CERTIFICATE OF APPROPRIATENESS

Property: 1212 Tulane Street, Lot 27, Block 183, Houston Heights Subdivision. The property includes a historic 1,580 square foot, 1½-story wood frame single-family residence situated on a 4,400 square foot (33' x 132') interior lot.

Proposal: Alteration – Revision. Construction of a rear two-story 1,621 square foot addition beginning at the rear wall was granted approval at the HAHC in January 2015. All existing original 1-over-1 windows and original 117 wood siding were to be retained and repaired.

WEST ELEVATION – FRONT FACING TULANE STREET

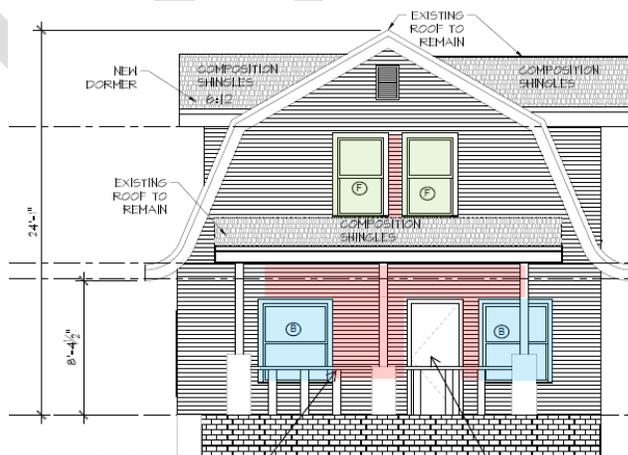
June 2015: The applicant has exceeded the approved scope of work. Significant portions of the original siding have been removed and replaced, especially on the first story. All trim has been removed. All original windows have been removed and replaced with flange mounted vinyl windows. The two front windows were also reduced in width. The original portion of the house was raised 8" separating the porch roof from the columns (which are now topped by blocking). See drawings and photos for more detail.

- Removed Siding
- Reinstall Original Windows
- Install Replacement Composite Windows

NORTH SIDE ELEVATION

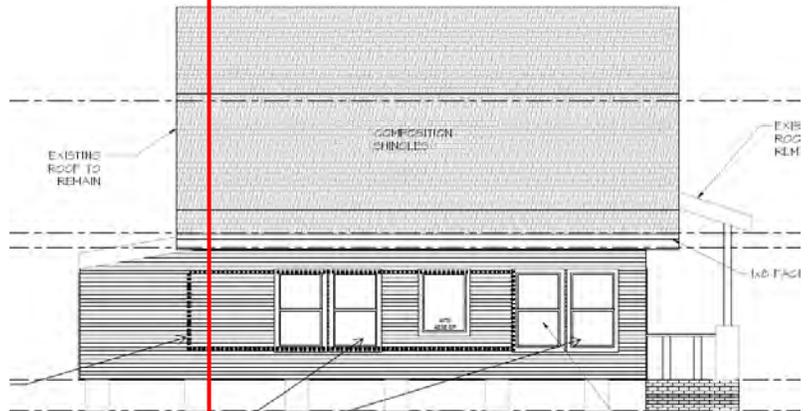
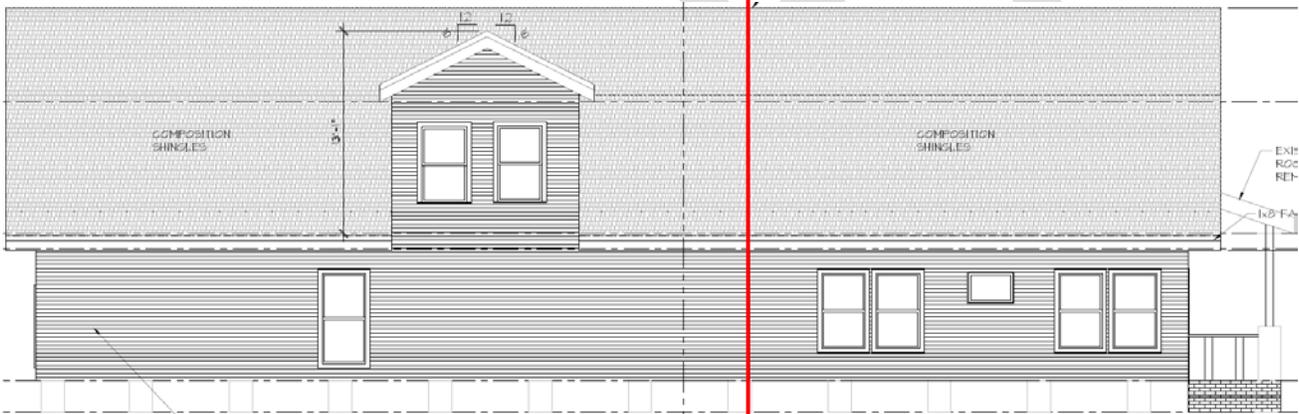
June 2015: The applicant has exceeded the approved scope of work. The original portion of the house was raised 8" separating the porch roof from the columns (which are now topped by blocking). Significant portions of the original siding have been removed and replaced. All original windows have been removed and replaced with flange mounted vinyl windows. The westernmost pair of windows has also been significantly altered. The western window of this pair has been shifted to the west while the eastern window has been removed altogether. The addition now has three pairs of windows, five more windows than originally approved. See drawings and photos for more detail.

- Removed Siding
- Reinstall Original Windows
- Install Replacement Composite Windows

SOUTH SIDE ELEVATION

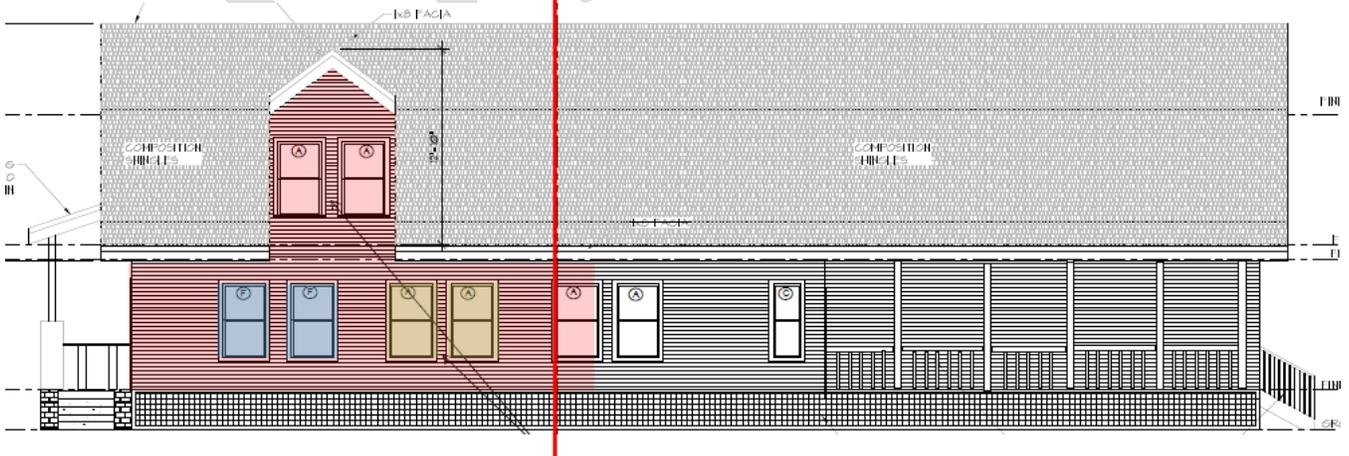
June 2015: The applicant has exceeded the approved scope of work. The original portion of the house was raised 8" separating the porch roof from the columns (which are now topped by blocking). All original siding has been removed and replaced. All original windows have been removed and replaced with flange mounted vinyl windows. The addition now includes two more windows than originally approved. The rear inset portion is now a porch with five columns and a railing system. The proposed additional dormer was never constructed. See drawings and photos for more detail.

- Removed Siding
- Reinstall Original Windows
- Install Replacement Composite Windows
